ADDENDUM - 01

DATE:Monday, 20 March 2023

RYEB Project #5718A
Salem City BOE
SALEM HIGH SCHOOL STADIUM
NJDOE SP#: 4630-050-23-1000

SALEM CITY SCHOOL DISTRICT
HOME & VISITOR BLEACHERS
SALEM, NEW JERSEY

FOUNDATION NOTES

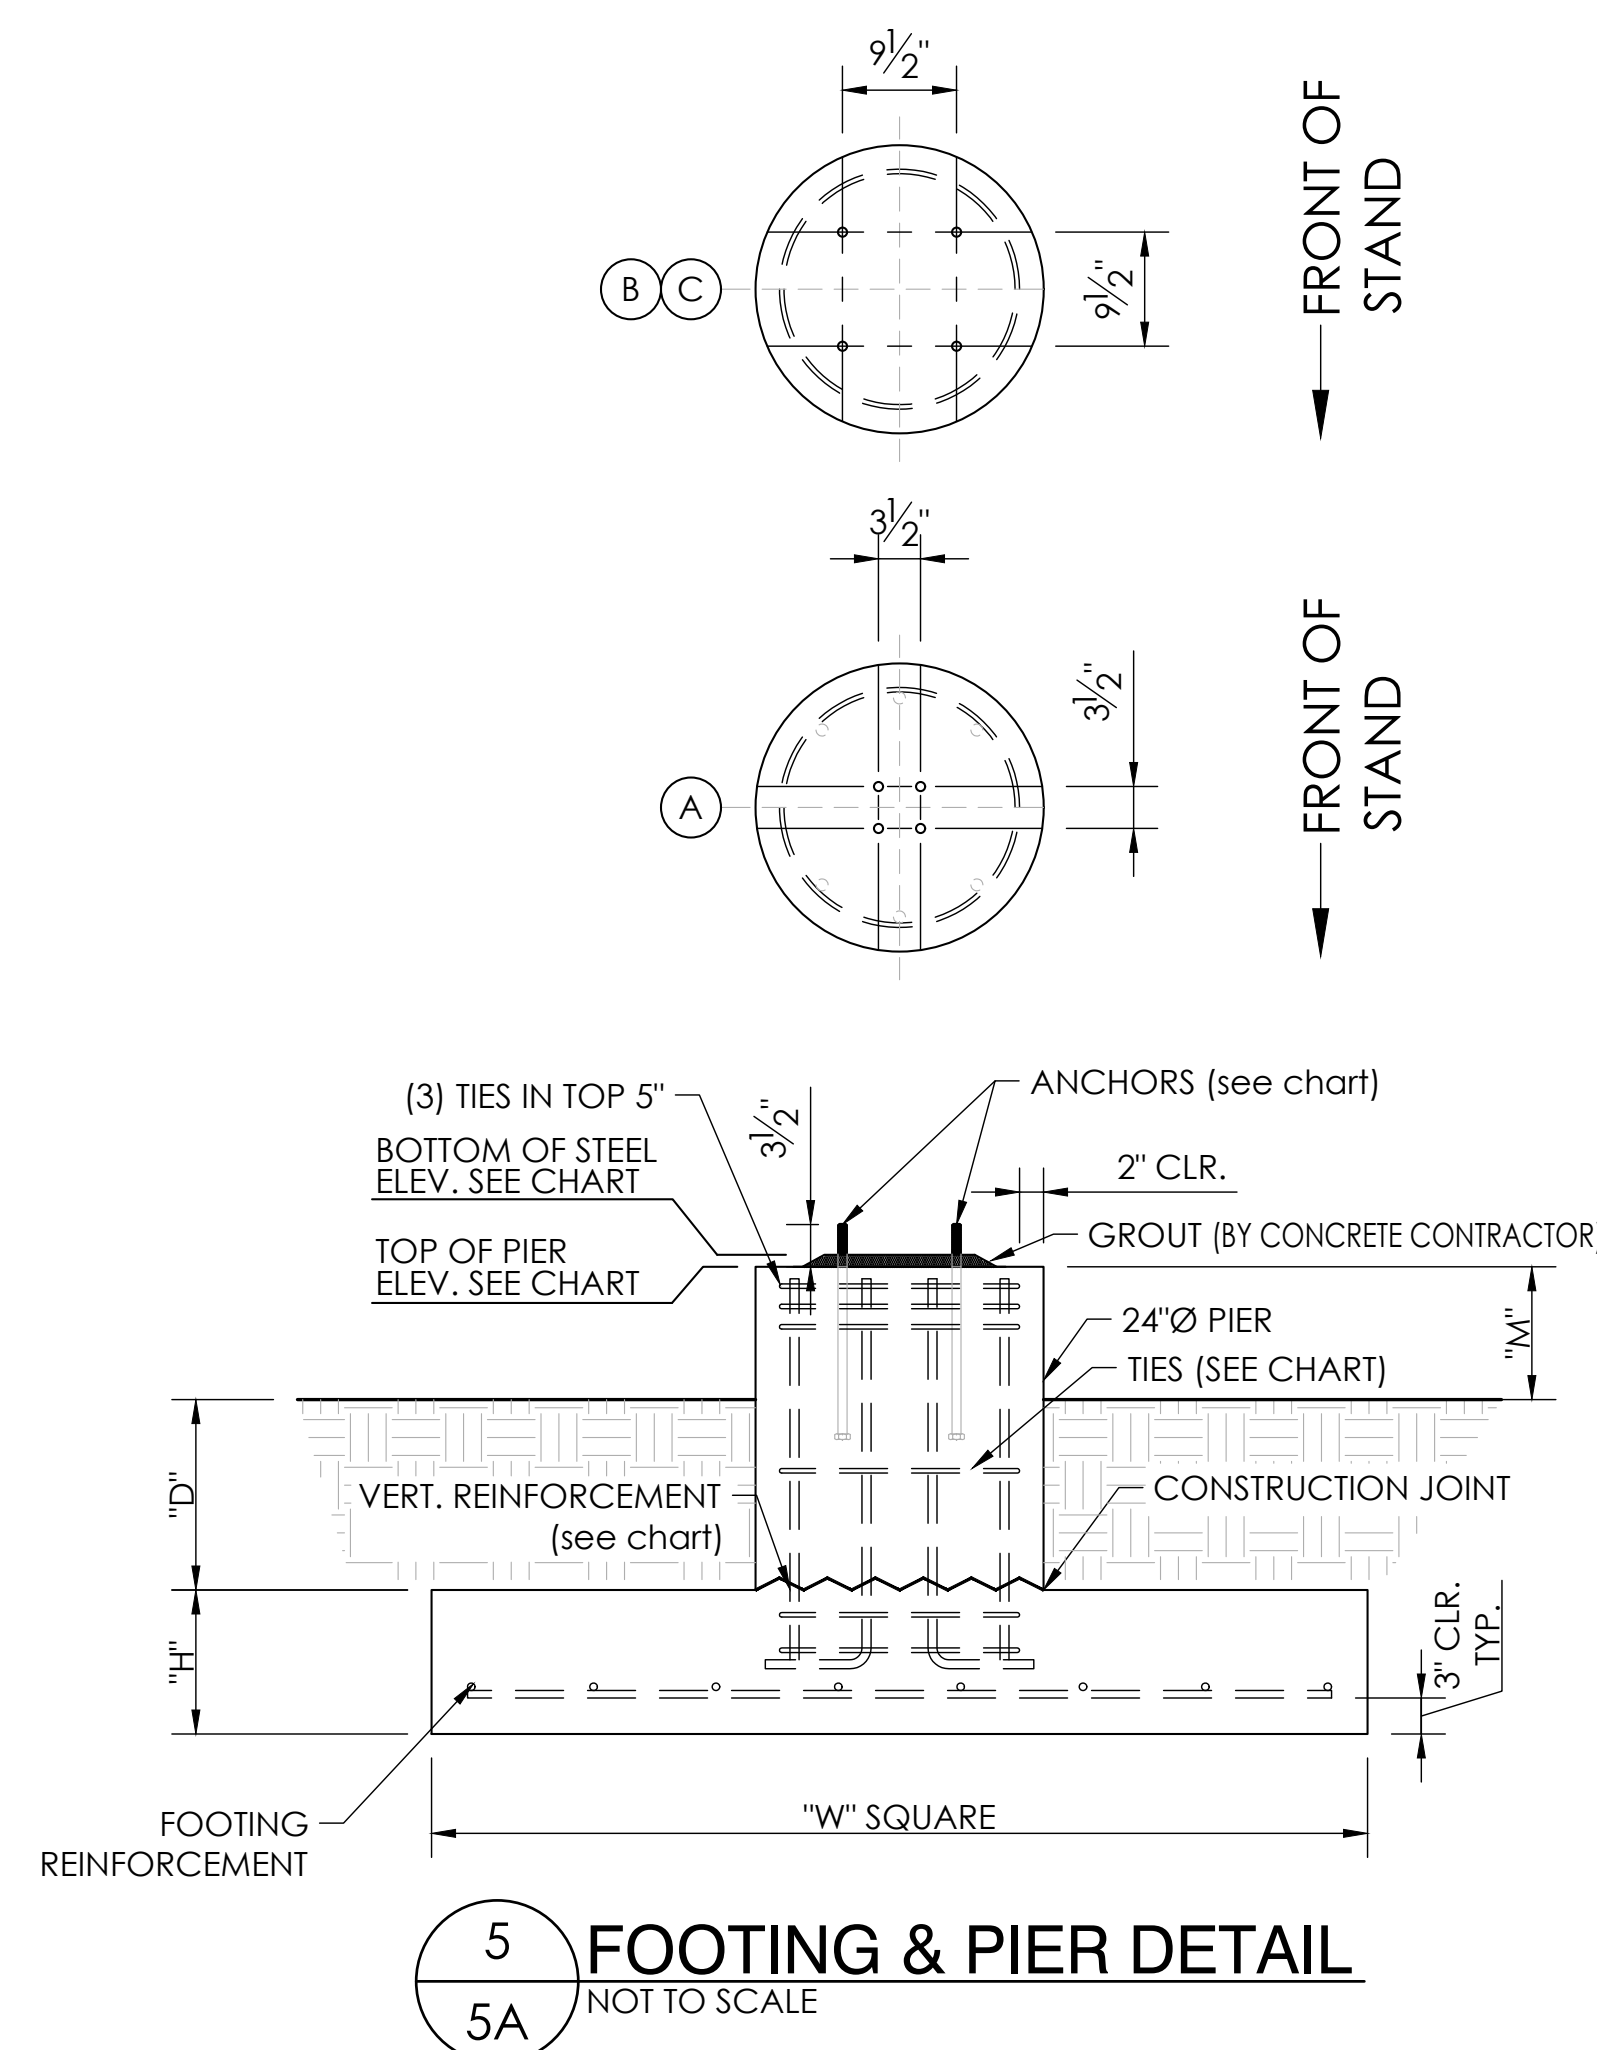
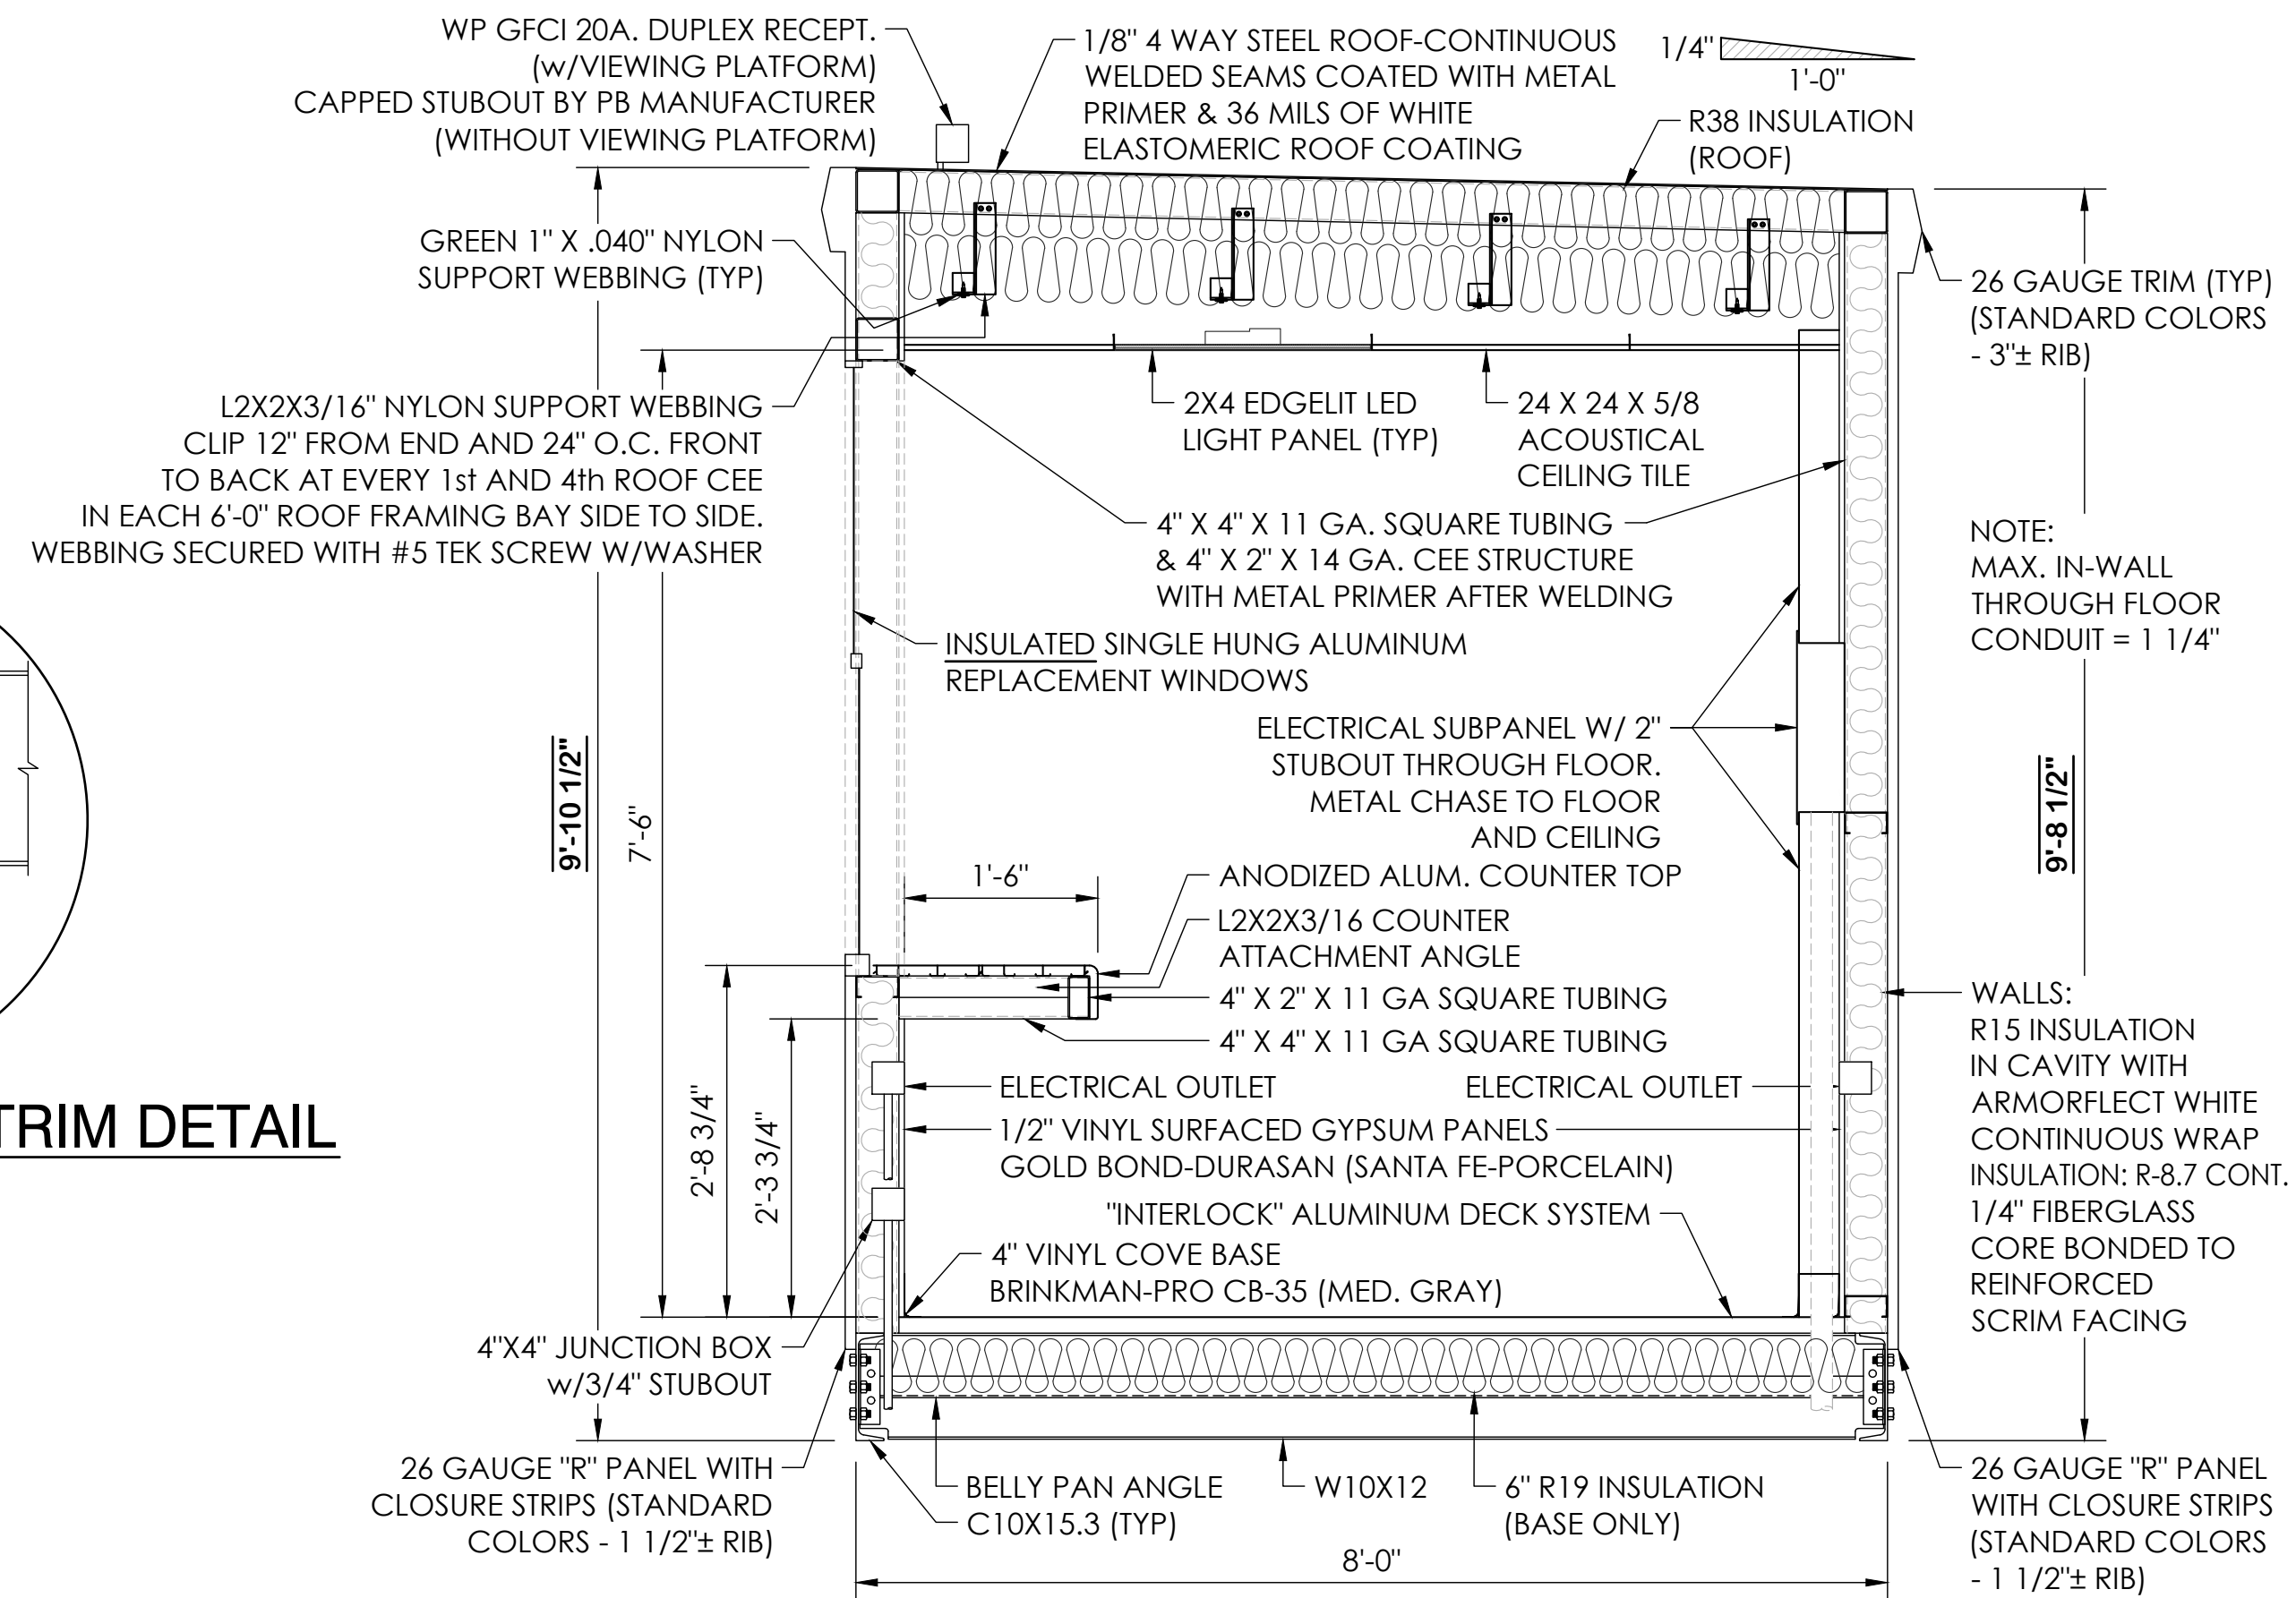
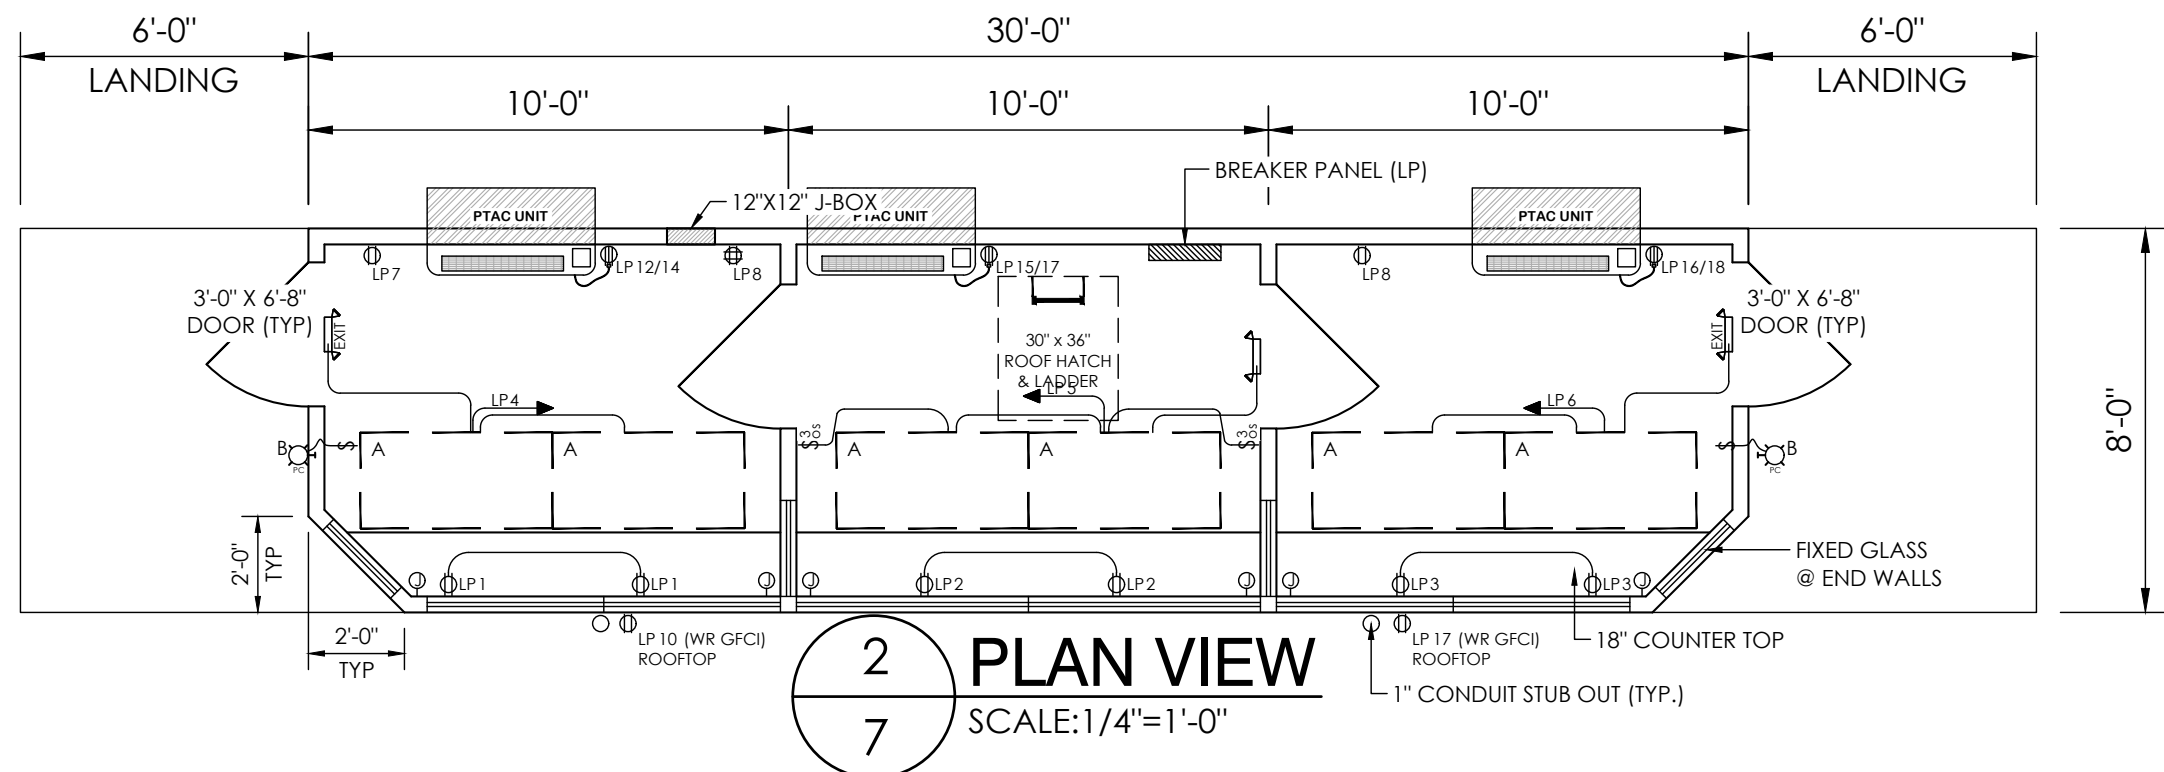
2. Concrete foundations shall be installed below frost level.
